Final Report of Special Inspections

Project: *Addition and Renovations*
Location: *214 Danforth Street, Portland, ME*
Owner: *Shalom House, Inc.*
Owner's Address: *106 Gilman Street*
Portland, ME 04102

JOB NAME: 214 Danforth Street
JOB NO.: 14005
DATE OF VISIT: Sep 09, 2014
TIME: 1:00 P.M.
WEATHER: 70°, clear
CLIENT: Shalom House
OBSERVERS: David Tetreault, SDC

1 BASEMENT PLAN
1/4" = 1'-0"

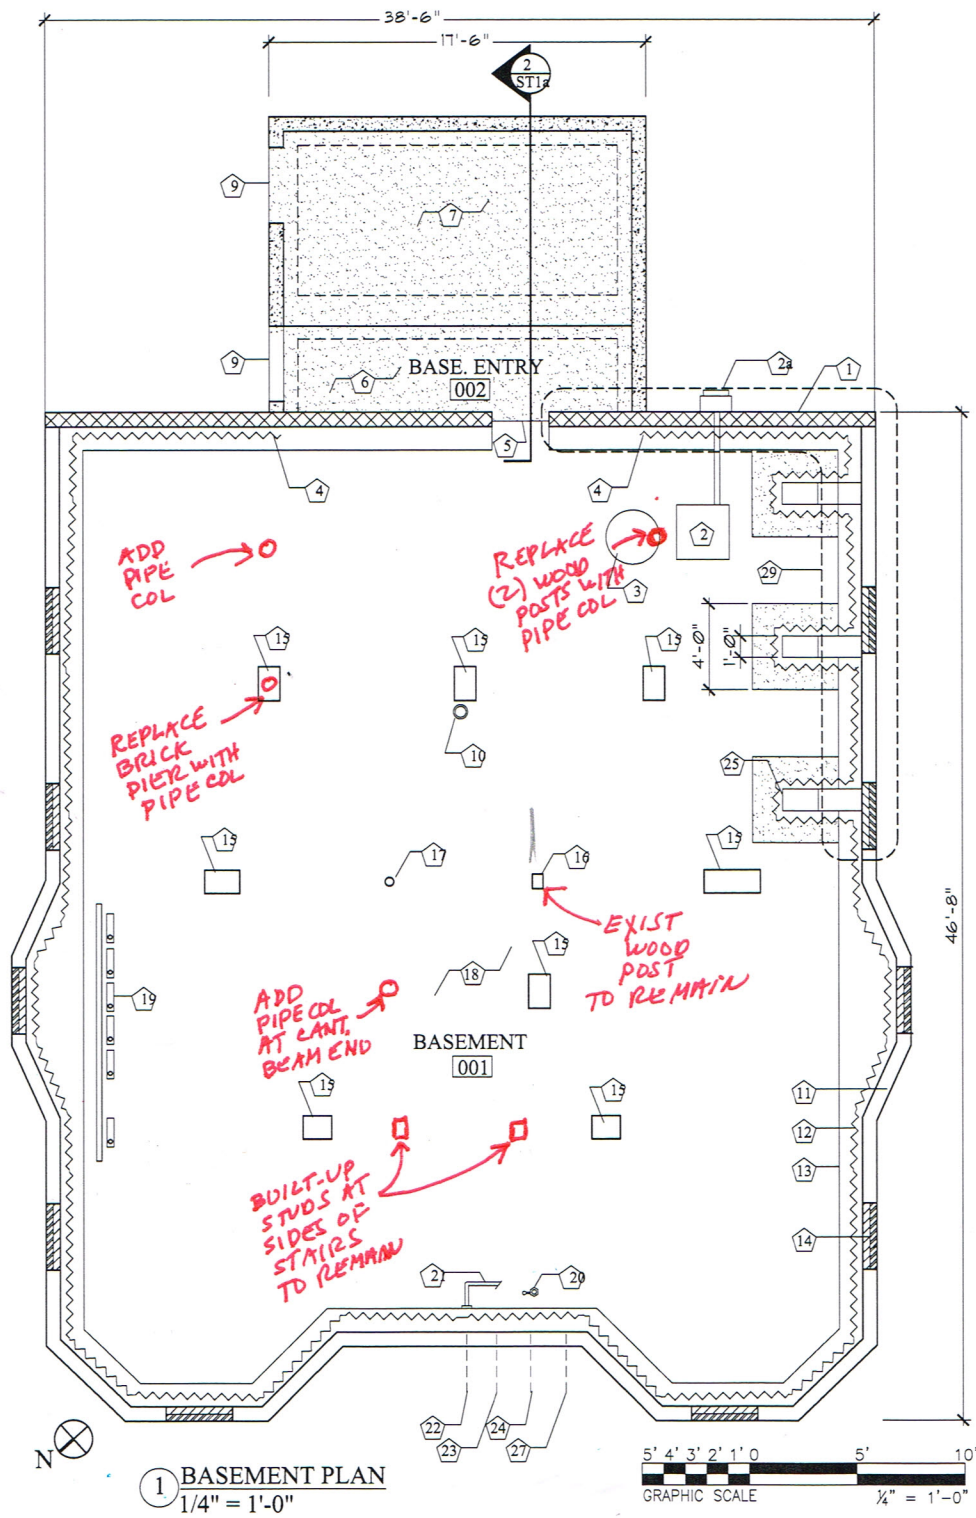
Demolition of finishes has been substantially completed. Several areas that have been exposed in the basement require revisions from the Contract Documents. See the attached Basement Plan.

The foundation at the west side has been exposed. Loose bricks and granite pieces must be removed prior to placing concrete for the buttress detailed on sheet ST-1a. A 1st floor beam is supported on the foundation approximately 13 feet south of the rear wall. This beam must be temporarily shored before removing loose brick and granite.
